COMPREHENSIVE PIPELINE INSPECTION REPORT

Project Name:	Mountain Valley Pipeline	Inspector:	Matt Grant
Inspection Date:	Tuesday, September 18, 2018		
Spread: Franklin County, MP 269 St#14249-14234, MP 265 St#13998-14000, St#13807 MP261	Spread I	Weather (Wet/Dry/Rain):	Wet

PIPELINE INSPECTION REPORT REQUEST FOR CORRECTIVE ACTION

Fig. 2

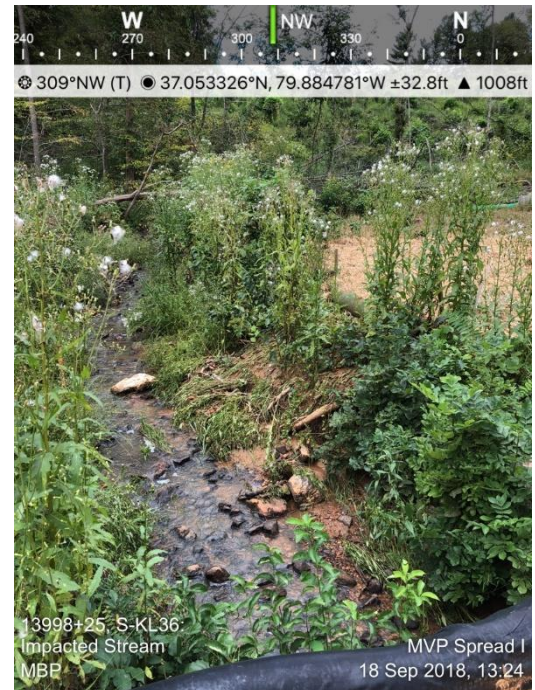
28	Va. Code §62.1-44.15:31) (MVP Standards & Specifications for VA, p. 1) (9VAC 25-840-40.19).	Observation: Sediment off of ROW, St#14000+00 and designated stream S-KL36. These areas have been noted in the SWPPP as impacted areas. <u>Recommended Corrective Action:</u> Remove Sediment per DEQ approval.

Description: Station 13998+25: Impacted Stream S-KL36
